# Access Compliance Report

## Public Rights-of-Way (Curb Ramps)

Intersection ID: 48941	Main Street: PEPPERPIKE_WY	Cross Street: MORGAN_LEE_AV	Location:	W
ADA ID: 883F2F94A07C	Ramp Type: Perp	Initial Pass/Fail: Fail	Overall Compliance: No	Severity Score: 10
Codes/Mitigation Info/Possible Solution		Field Measurements/Component Compliance

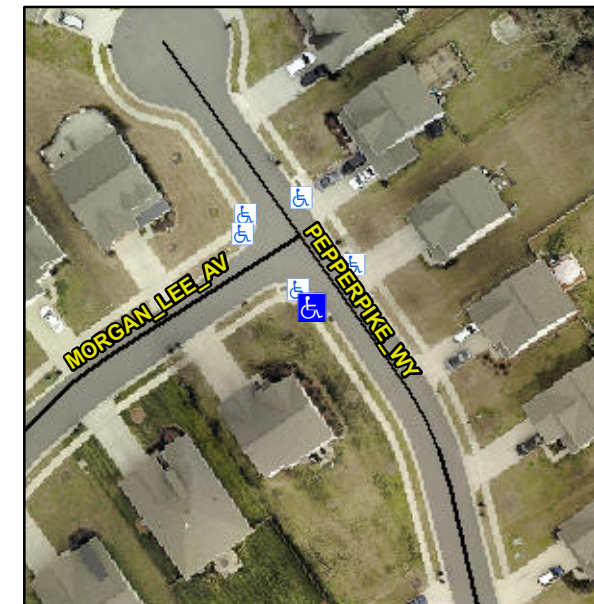
**Not Found, R304.5.1**

Compliance	Description	Data	Compliance	Description	Data
N/A	Ramp Length (in)	49.5	Yes	Ramp Slope (%)	5.8
No	Ramp Width (in)	47.0	Yes	Ramp XSlope (%)	2.1
N/A	Flare Type LT	N/A	N/A	Flare Type RT	N/A
N/A	Flare Slope LT (%)	N/A	N/A	Flare Slope RT (%)	N/A
N/A	Flare Traversable LT?	N/A	N/A	Flare Traversable RT?	N/A
N/A	Landing Length (in)	N/A	N/A	DWS Provided?	N/A
N/A	Landing Width (in)	N/A	N/A	DWS Contrast?	N/A
N/A	Landing Slope (%)	N/A	N/A	DWS Length (in)	N/A
N/A	Landing X Slope (%)	N/A	N/A	DWS Full Width?	N/A
N/A	Landing Curb? (Y/N)	N/A	N/A	DWS Offset (in)	N/A
N/A	Shared Landing?	N/A			
N/A	Gutter Ponding?	N/A	N/A	Gutter Slope (%)	N/A
N/A	Gutter Lip Ht (in)	N/A	N/A	Gutter X Slope (%)	N/A
N/A	Painted X Walk1?	No	N/A	Painted X Walk2?	N/A
	X Walk 1 Direction	To E		X Walk 2 Direction	N/A
N/A	X Walk 1 Width (in)	N/A	N/A	X Walk 2 Width (in)	N/A
	X Walk 1 Slope (%)	3.7		X Walk 2 Slope (%)	N/A
	X Walk 1 X Slope (%)	3.1		X Walk 2 X Slope (%)	N/A

**Remove & Replace Entire Ramp.**
